# Keystone RV Company

## SAFETY ADVISORY # 17-301

### IOTA Transfer Switch Replacement

**Fig. 1****Fig. 2**

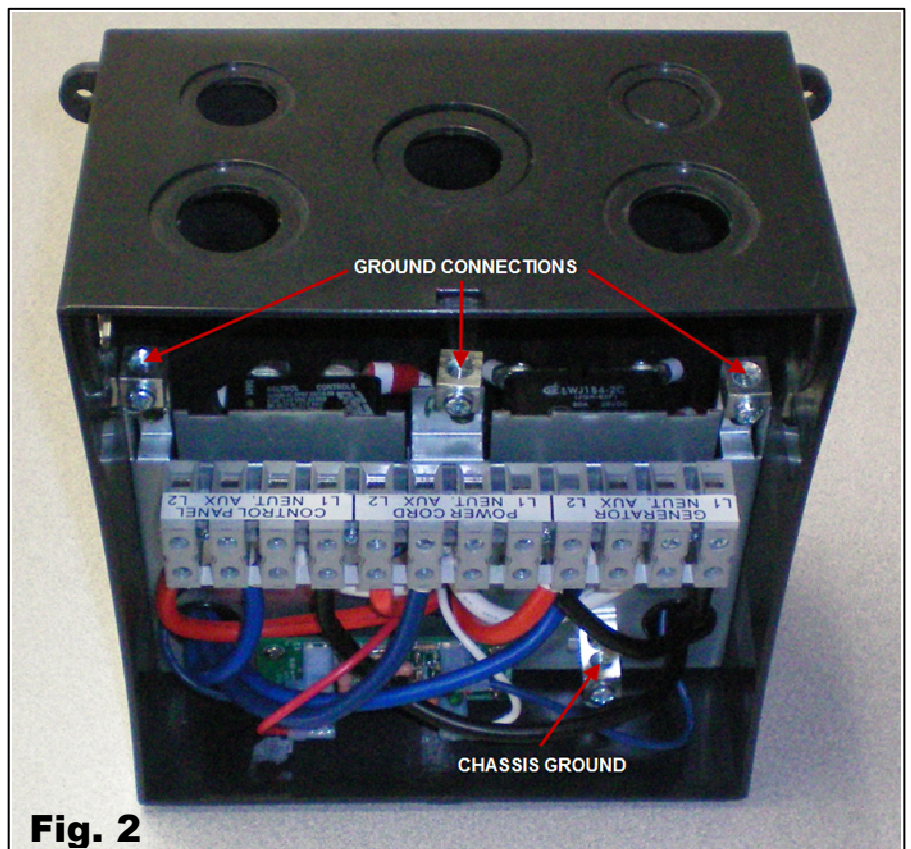
Inspect the Transfer Switch to verify it is an IOTA ITS-50R as shown in Figure 1. If it is not an IOTA ITS-50R - go to Warranty Reimbursement and submit a claim for Inspection Only. No further action is necessary.

Remove the IOTA ITS-50R transfer switch. **Do not discard – see PART RETURN for further instructions.**

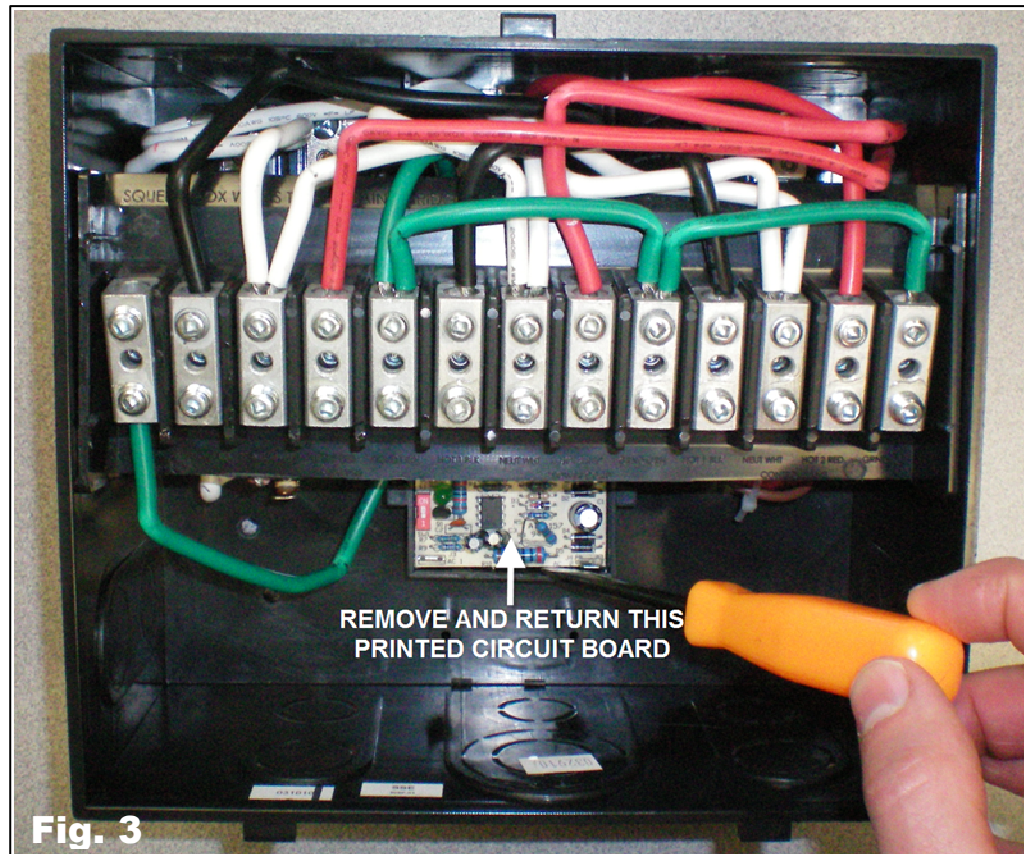
Connect the generator, power cord, and control panel wires where indicated on the new transfer switch. The ground wires connect where shown in Figure 2. The AUX connection will not be used and will be left empty.
